**Subject: Silver Lake Dam (P-10855)
FERC Independent Consultants Review Panel Report
Comments of MWH Americas, Inc.**

MWH Americas, Inc. ("MWH"), which designed the facilities constructed at Silver Lake in 2002, has reviewed the Independent Consultants Review Panel Report filed with FERC on December 18, 2003 ("Panel Report"). We appreciate that the Panel had to consider a substantial amount of information in a limited time period, and we commend its efforts. However, we believe that some of the Panel's conclusions, particularly as to "root cause," do not follow from the information available to the Panel. We therefore offer the following comments on critical issues, on behalf of MWH.

CHICAGO, ILLINOIS DATE DWG. NO. 20895-C1

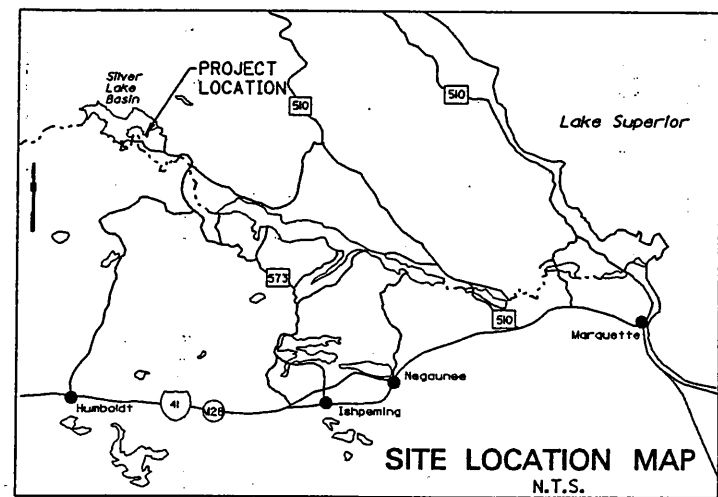
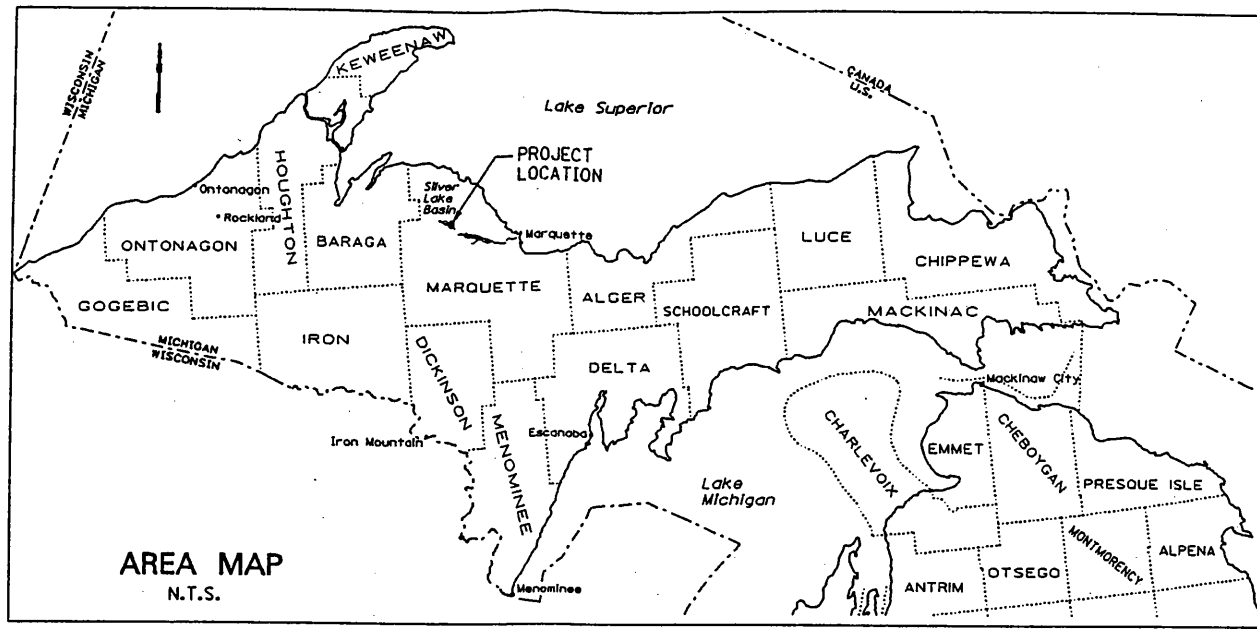
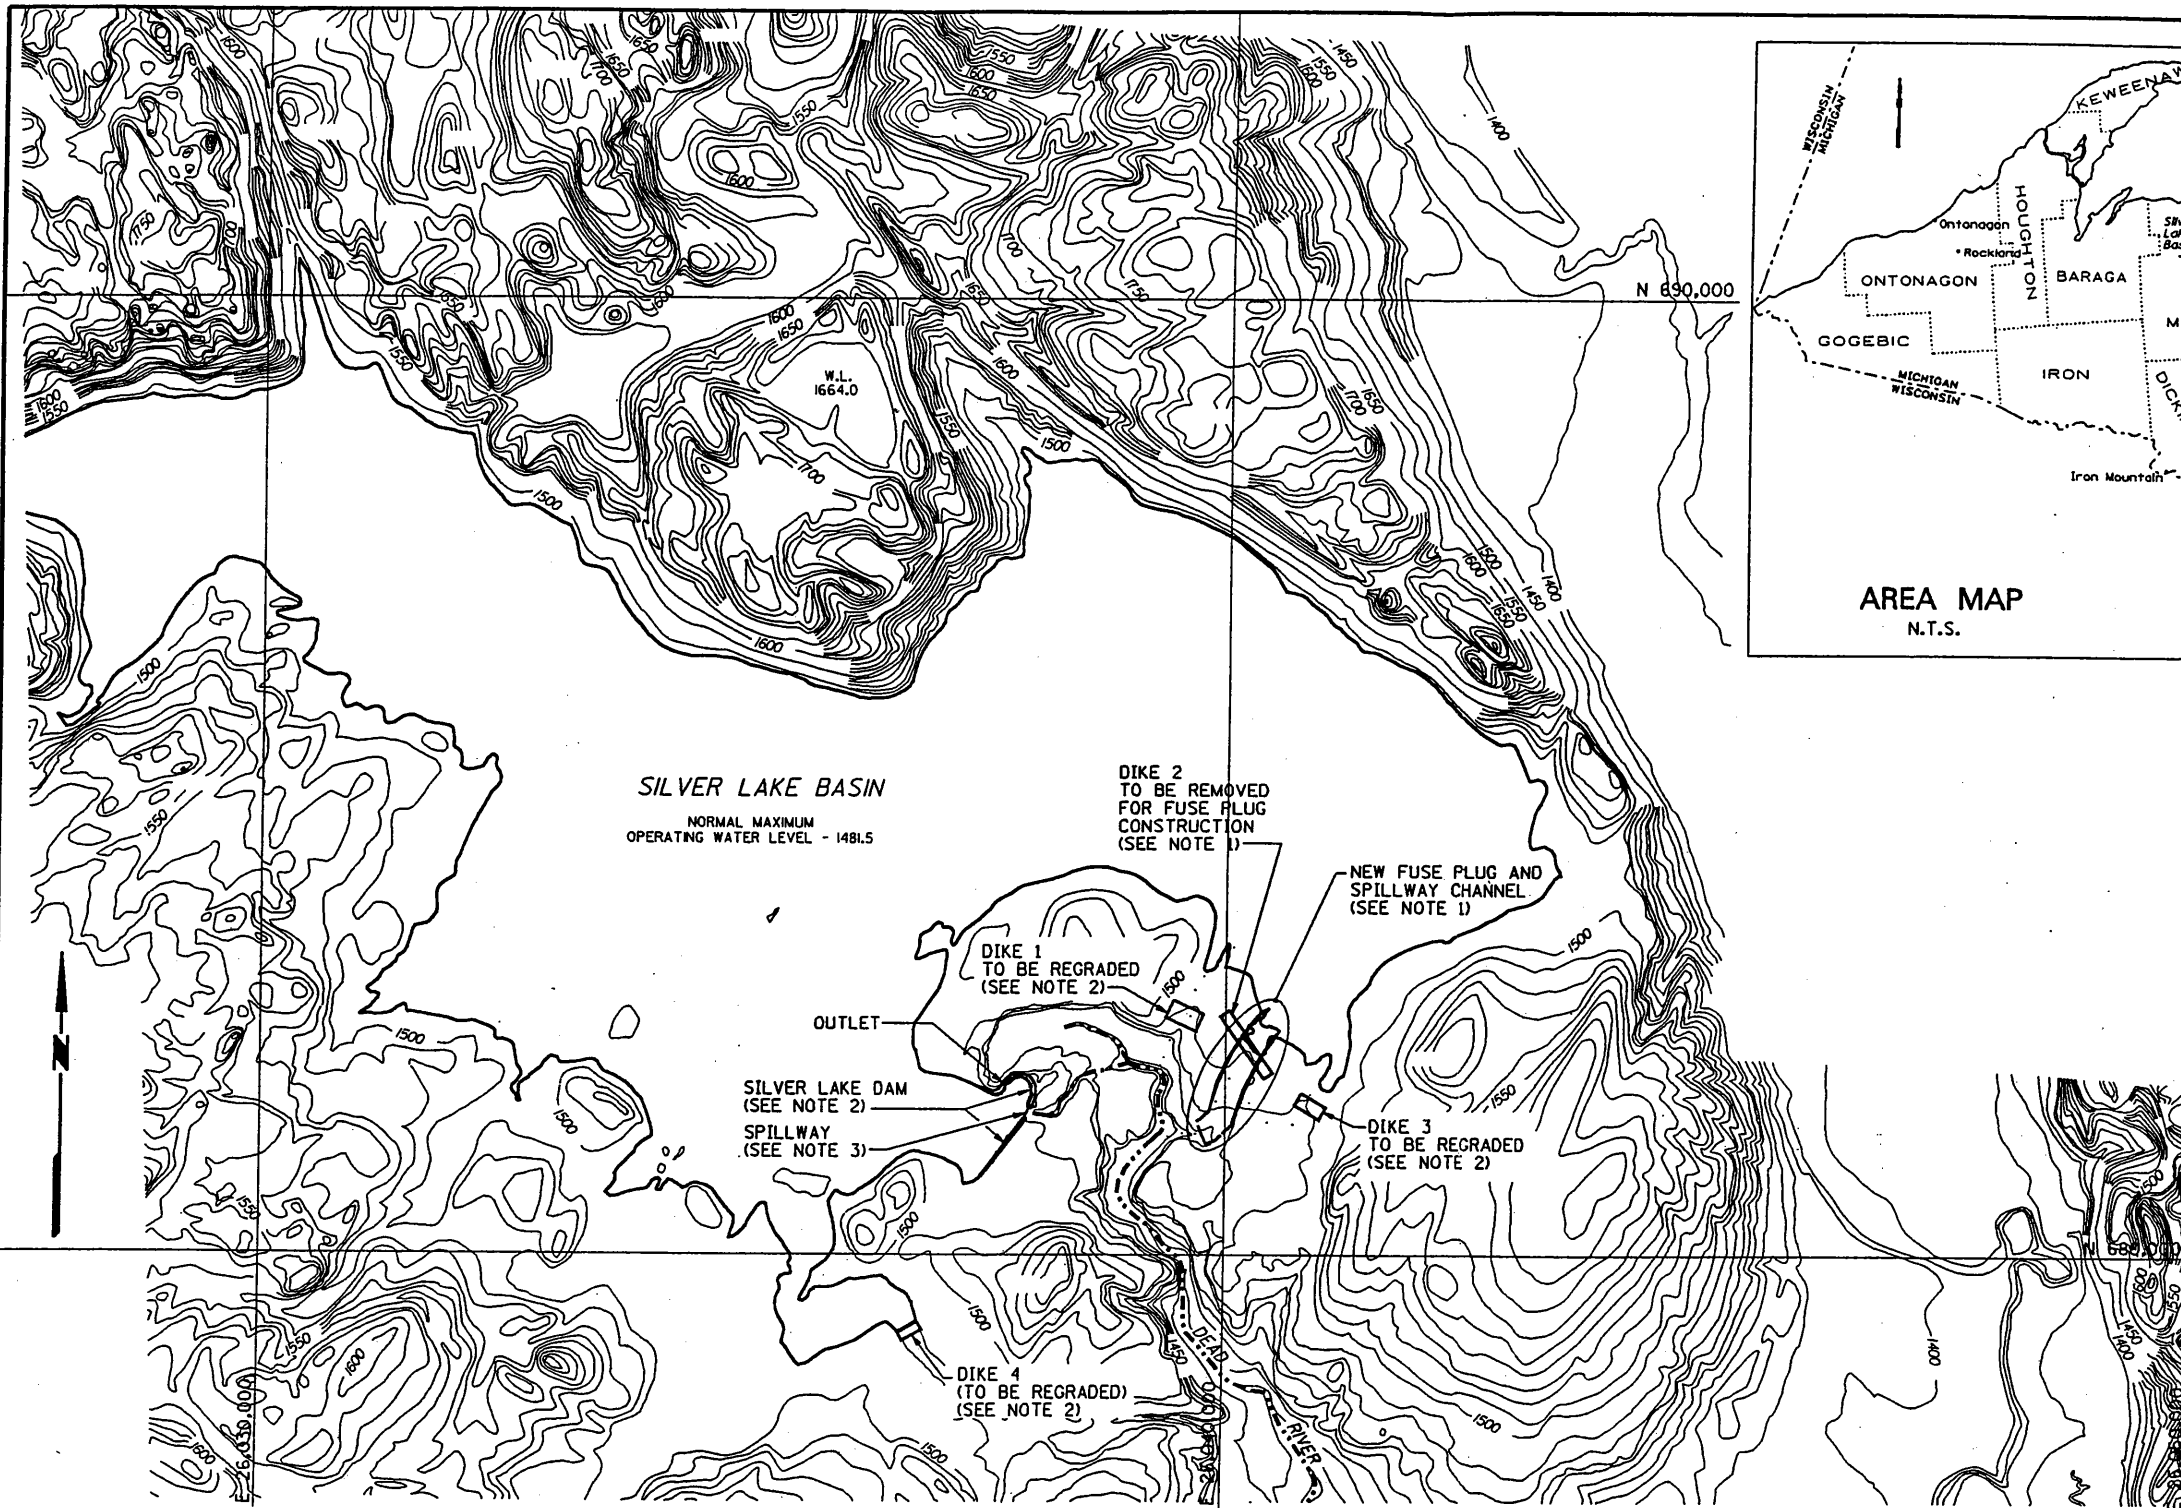
In addition to the clear legal obligations of its FERC license, as the owner and operator of the Silver Lake Reservoir, UPPCO had a duty to downstream riparians and the general public to operate the reservoir to avoid overfilling. To guard against overfilling, the stoplogs should have been removed – as a baseline condition – to 1482.5 feet. This point was emphasized by MWH in its 2001 and 2002 Design Reports and by FERC in a letter to UPPCO dated May 16, 2002 – a full year before the breach. Further, UPPCO was fully aware that stoplog removal to 1482.5 feet was an integral part of the construction project. *See* exhibits 1 and 2 enclosed with this letter — Construction Drawing C-1 (Exh. 1), submitted to UPPCO on May 29, 2001 (Exh. 2).
